**From:** Wesley Held  
**To:** <arspears@southernco.com>, <jtdavis@southernco.com>  
**Date:** 8/31/2007 4:05:06 PM  
**Subject:** Section 2.5 Part 1 of SER  
**cc:** "Christian Araguas" <CJA2@nrc.gov>

## **2.5 Geology, Seismology, and Geotechnical Engineering**

In Section 2.5, “Geology, Seismology, and Geotechnical Engineering,” of the VEGP SSAR, the applicant described geologic, seismic, and geotechnical engineering properties of the VEGP ESP site. SSAR Section 2.5.1, “Basic Geologic and Seismic Information,” presents information on geologic and seismic characteristics of the VEGP site and region surrounding the site. SSAR Section 2.5.2, “Vibratory Ground Motion,” describes the vibratory ground motion assessment for the ESP site through a PSHA and develops the SSE ground motion. SSAR Section 2.5.3, “Surface Faulting,” evaluates the potential for surface tectonic and non-tectonic deformation at the ESP site. SSAR Sections 2.5.4, “Stability of Subsurface Materials and Foundations,” 2.5.5, “Stability of Slopes,” and 2.5.6, “Embankments and Dams,” describe foundation and subsurface material stability at the ESP site.

Figure 2.5.2-2 - Alternative geometries comprising the UCSS model updated Charleston seismic source (reproduced from SSAR Figure 2.5.2-9)

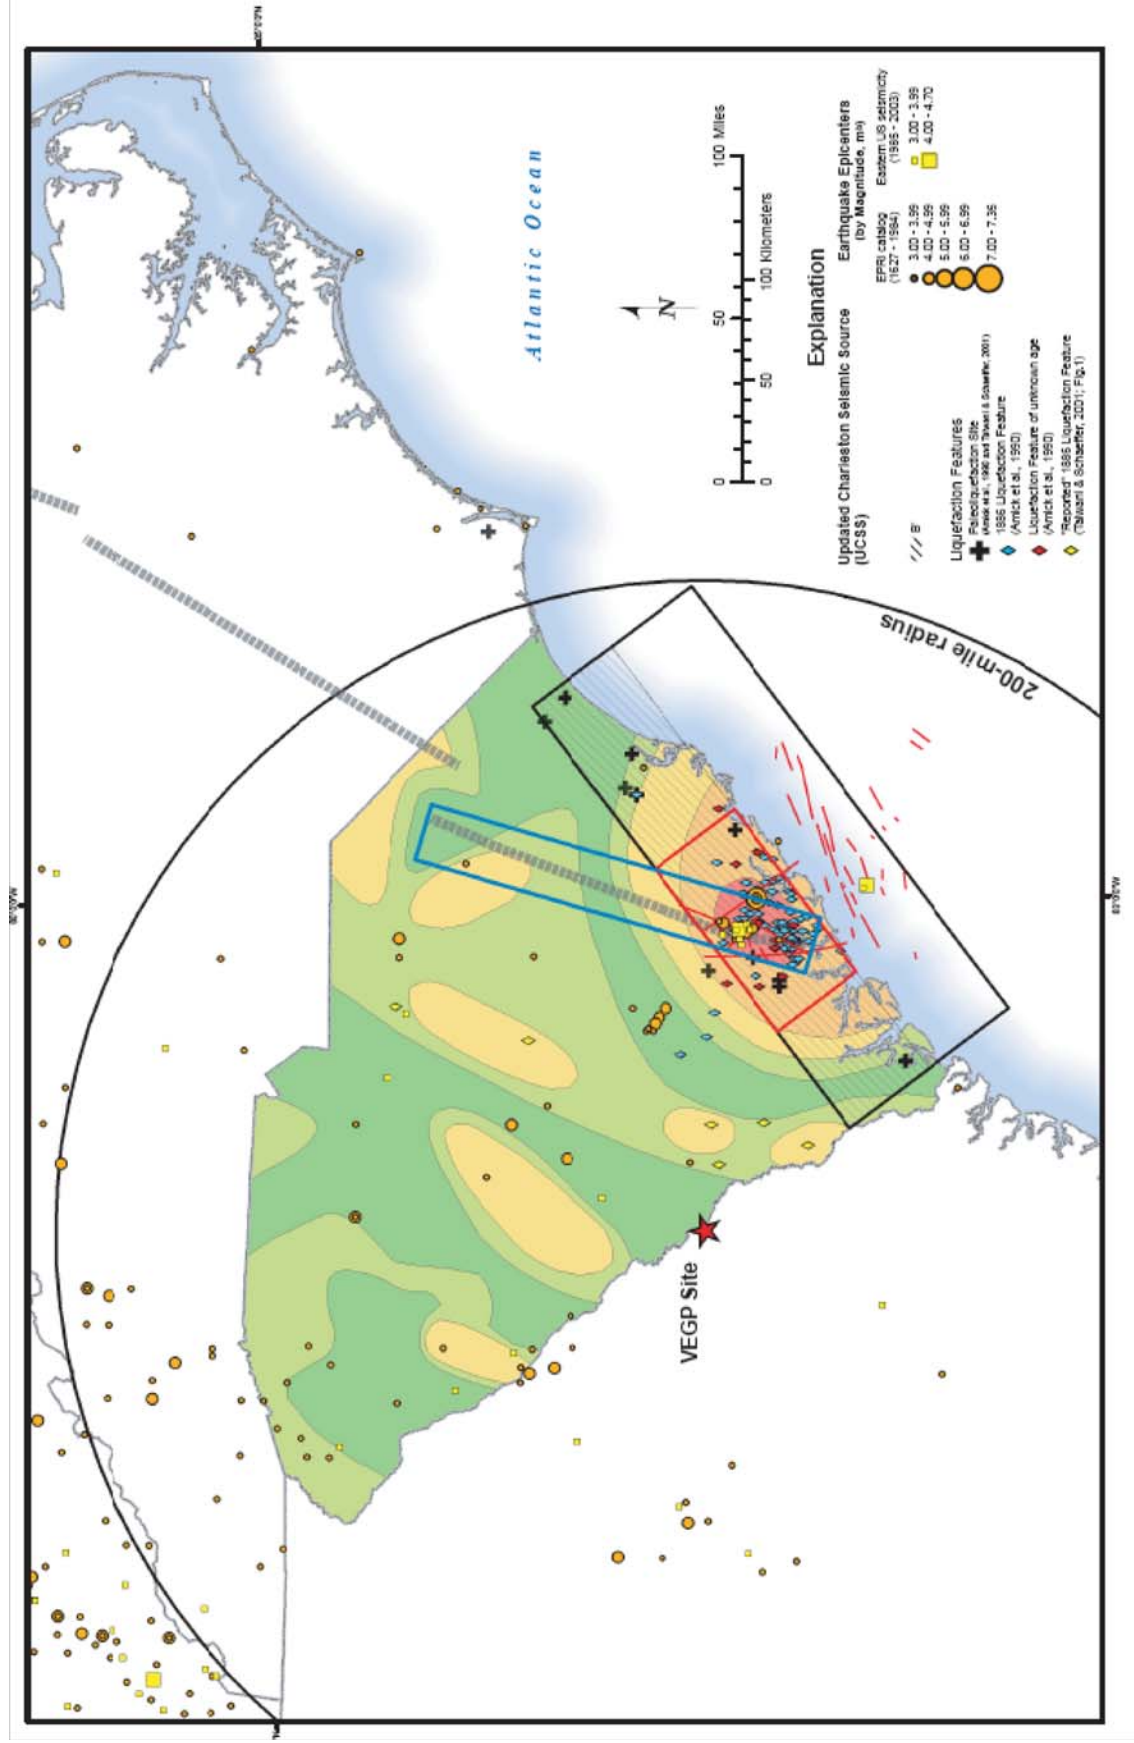
Charleston Seismic Source Zone Geometries. For its update of the Charleston seismic source zone, the applicant developed new source zone boundaries. Specifically, as described in SSAR Section 2.5.2.2.4, the applicant developed four, mutually exclusive source zone geometries, referred to as A, B, B', and C, to represent the Charleston seismic source. These four source zones are shown in SER Figure 2.5.2-2 (reproduced from SSAR Figure 2.5.2-9). SSAR Section 2.5.2.2.2.4.1 states that the width of Geometry B is 80 kilometers (50 miles). However, SSAR Figure 2.5.2-9 (and SER Figure 2.5.2-2) show that

the width of Geometry B is 100 kilometers (62 miles). In RAI 2.5.2-14, the staff asked the applicant to provide the actual dimensions of Geometry B used for the UCSS. In response, the applicant stated that the width of UCSS Geometry B is 100 kilometers and not 80 kilometers, as stated in SSAR Section 2.5.2.2.4.1. Based on the applicant's clarification of the width of source zone B, the staff concludes that the source referred to as Geometry B in SSAR Figure 2.5.2-9 is accurate.

Figure 2.5.2-11 - Comparison of the staff's 1-Hz hazard curves for the ETSZ for magnitudes ranging from M 6.0 to M 7.8

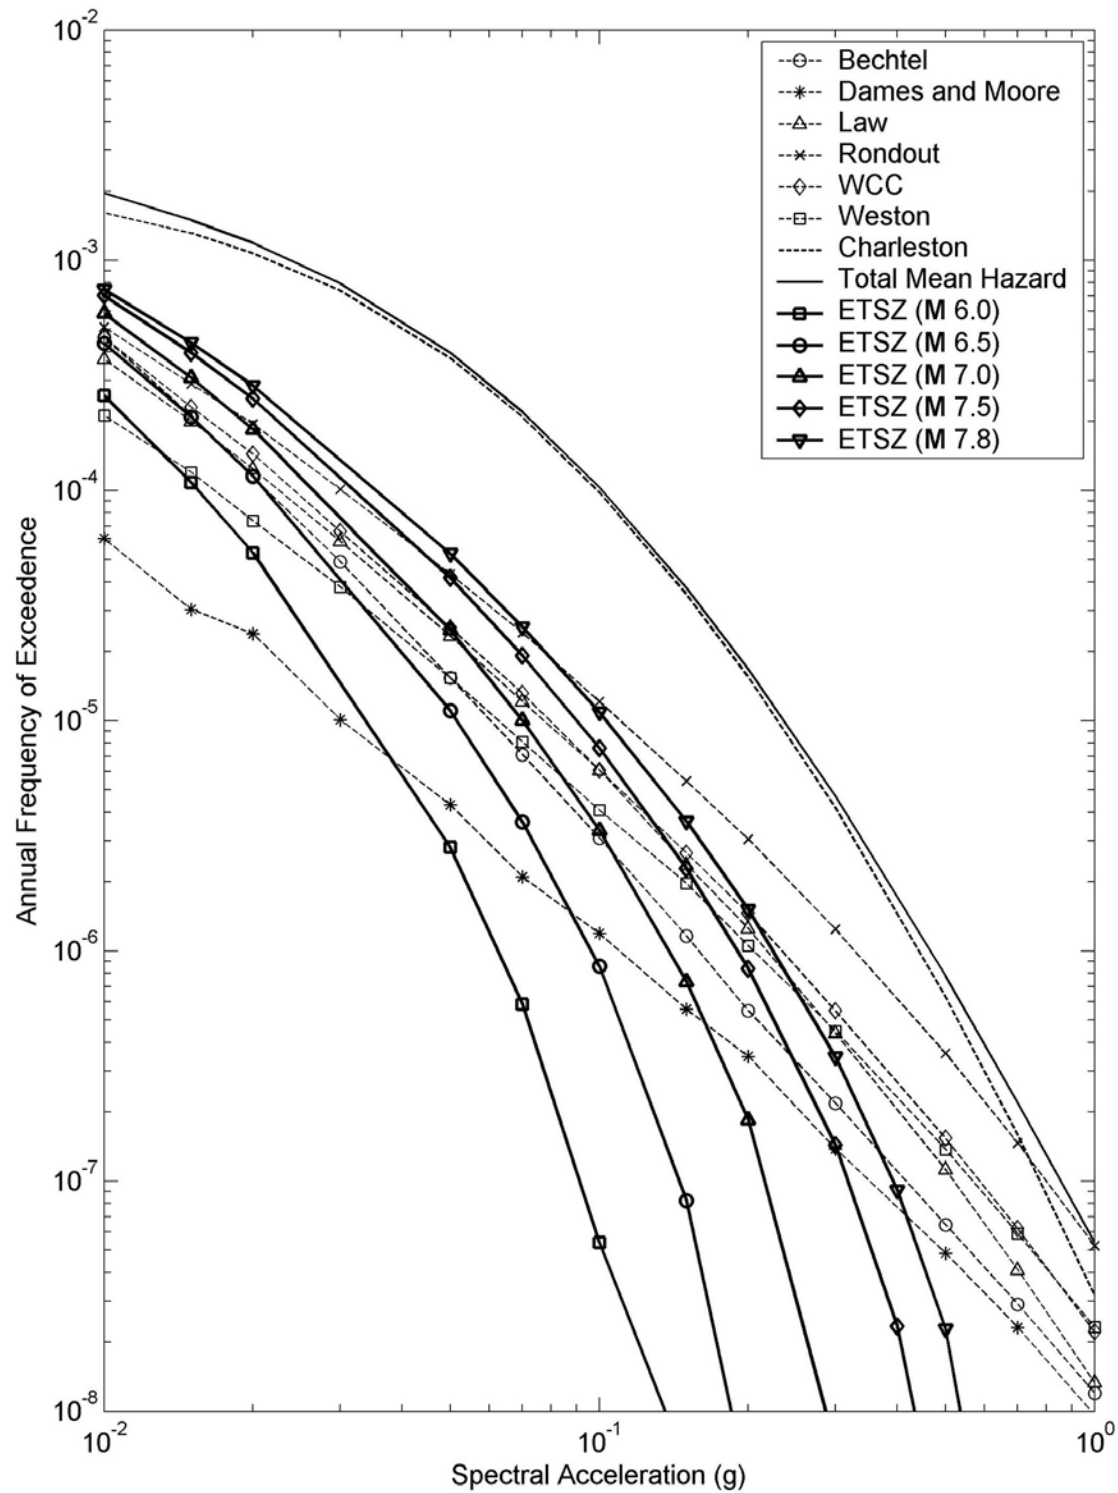
To validate the applicant's claim that the ETSZ hazard results are insignificant compared to the Charleston seismic source, the staff did a confirmatory analysis. The staff performed hazard calculations using maximum magnitudes for the ETSZ that ranged from M 6.0 to M 7.8. This magnitude range reflects more recent  $M_{\max}$  values assigned to the ETSZ, as shown in SER Table 2.2.5-6. SER Figure 2.5.2-11 shows the staff's 1-Hz hazard curves for the ETSZ using this range of  $M_{\max}$  values. SER Figure 2.5.2-11 also shows the applicant's total mean hazard curve and the Charleston seismic source zone contribution for comparison. The staff's results show that, although the Charleston seismic source zone clearly dominates the 1-Hz hazard, the contribution from the ETSZ for some of the larger  $M_{\max}$  values (greater than 7.0) may contribute significantly more than 1 percent to the total hazard for the ESP site.

The staff concludes that, despite the uncertainty regarding the potential for large earthquakes within the ETSZ, the results of post-EPRI source characterizations for the ETSZ suggest that the EPRI EST characterization of the ETSZ needs to be updated. The results of the staff's confirmatory analysis do confirm the applicant's assertion that the Charleston seismic source dominates the 1-Hz hazard. However, the staff concludes that the contribution of the ETSZ at the ESP site may be significant enough to warrant inclusion in the applicant's PSHA, if larger  $M_{\max}$  values are considered. This is **Open Item 2.5-3**.

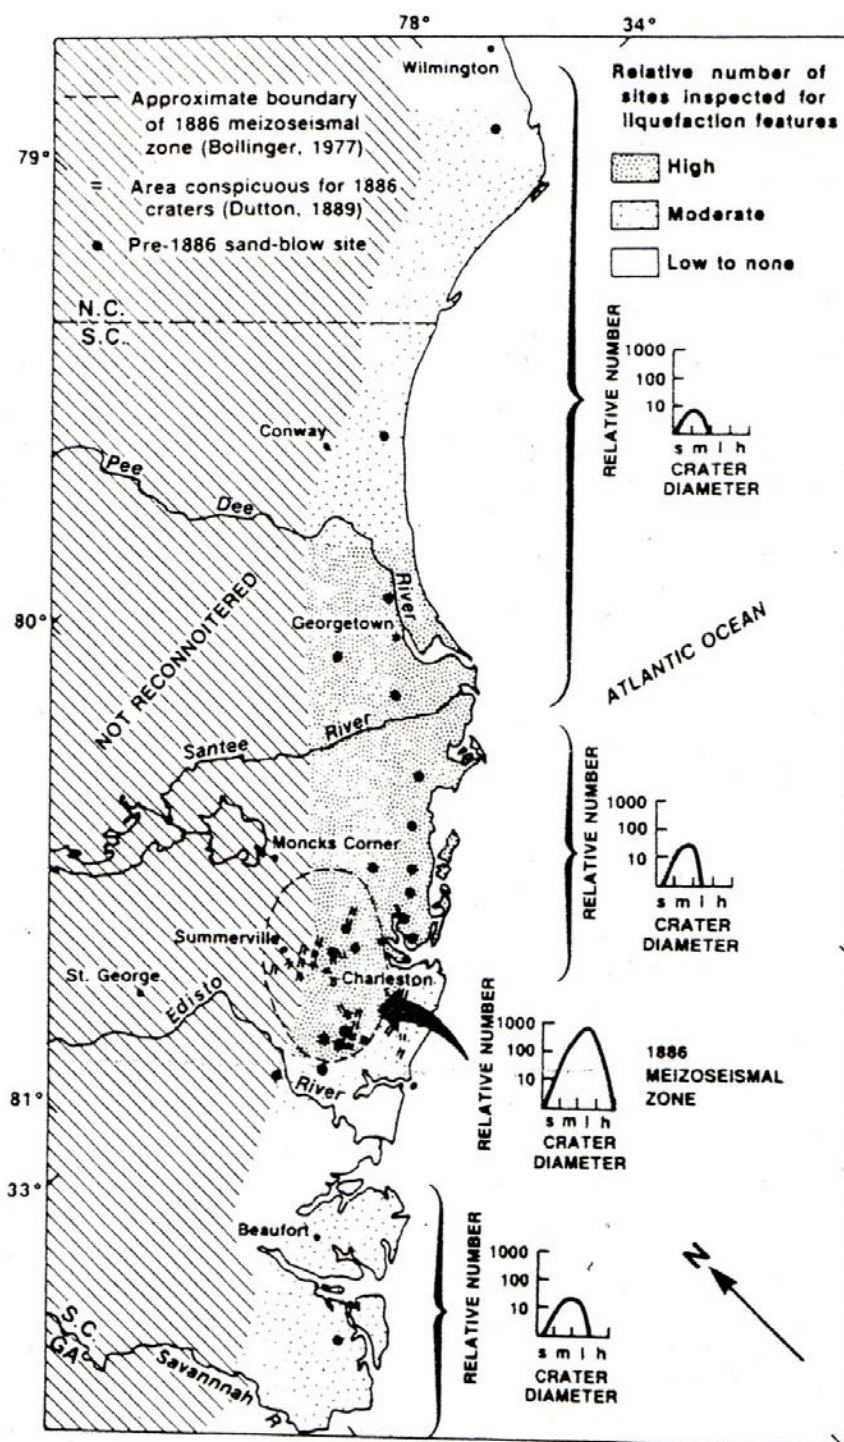
The staff also reviewed the study of Obermeier et al. (1989). Obermeier et al. (1989) conclude that, "Both the size and relative abundance of pre-1886 craters are greater in the vicinity of Charleston (particularly in the 1886 meizoseismal zone) than elsewhere, even though the susceptibility to earthquake-induced liquefaction is approximately the same at many places throughout this coastal region." Figure 4 of Obermeier et al. (1989), reproduced as SER Figure 2.5.2-12, depicts the sizes of various prehistoric liquefaction features and demonstrates that the largest craters of all ages concentrate near Charleston. The staff notes that the figure cannot exclude the possibility that one (or more) of the large prehistoric earthquakes created its (or their) largest liquefaction features elsewhere. However, Obermeier's (1989) figure shows four size classes of craters, with the largest prehistoric craters (wider than 3 meters) present only in the 1886 meizoseismal area. Only smaller craters are known farther south and north. Obermeier (1989) favors attributing some of these distant, small-to-medium-sized craters to infrequent moderate earthquakes at two separate sources far north and south of Charleston. The epicentral regions of 1886-sized earthquakes should have abundant craters wider than 3 meters, and they have been found only near Charleston. Sparse exposures preclude saying much about crater sizes between Beaufort and the Edisto River, south of Charleston (Obermeier et al. 1989) and south of Geometry A. Thus, it is unlikely, but possible, that the paleoliquefaction record of a large earthquake's meizoseismal region could be concealed south of Geometry A. However, this small probability is accounted for by Geometries B and B', which span most of the length of South Carolina's coast. The absence of known abundant paleoliquefaction features in North Carolina and Georgia, despite searches there (Amick and Gelinas 1991), suggests that Geometries B and B' need not extend beyond South Carolina.

(62 miles) inland from the coast. The occurrence of a large earthquake inland of the coast would necessitate different Charleston source zone models. See Open Item 2.5-5.

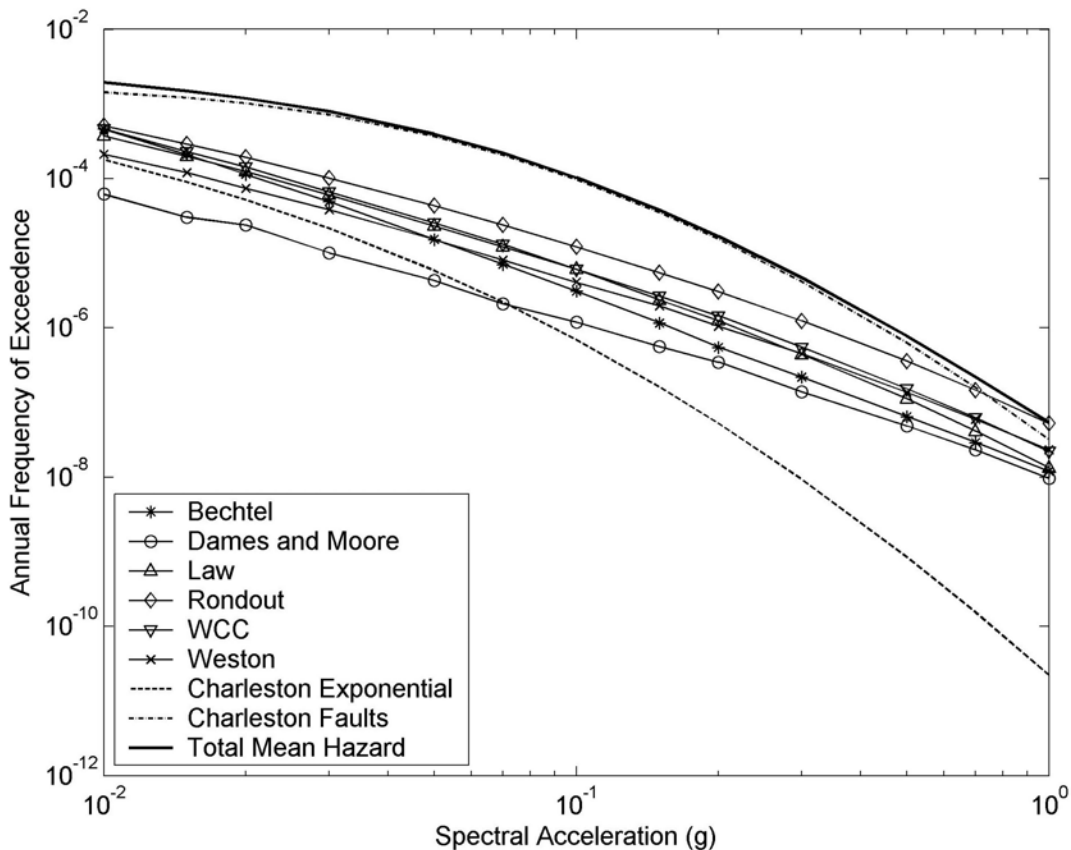
In order to determine the adequacy of the PSHA results, the staff, in RAI 2.5.2-1, requested the applicant to provide the 1- and 10-Hz mean hazard curves for each of the six EPRI ESTs, as well as the 1- and 10-Hz mean hazard curves for the UCSS model. In response to RAI 2.5.2-1, the applicant provided the requested hazard curves. SER Figures 2.5.2-13 and 2.5.2-14 show the applicant's 1-Hz and 10-Hz total mean hazard curves, as well as the hazard curves corresponding to each of the six EPRI EST seismic source model inputs. Both figures also show the hazard curves corresponding to the applicant's UCSS model.

As shown in SER Figure 2.5.2-13, for the 1-Hz hazard curves, the Charleston source dominates the overall hazard at the ESP site. In SER Figure 2.5.2-14, for the 10-Hz hazard curves, the contributions from each of the six ERPI seismic source models have a more significant contribution to the overall hazard.
